Product Bulletin

30013B01

Easier Recognition of diving breathing valves without Safety Pressure

LIDINGÖ April 20, 2011

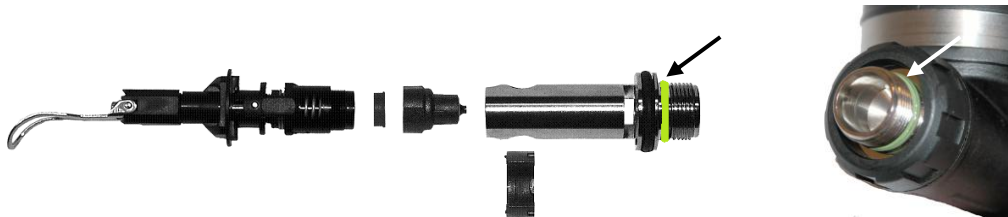
To ensure easier recognition of diving breathing valves without safety pressure, the connection O-ring has been changed to green and the Guide disc has been fitted with a hole.

The new green O-ring is visible at the breathing hose connector.

The new Guide disc for the Sealing spring is fitted with a hole.
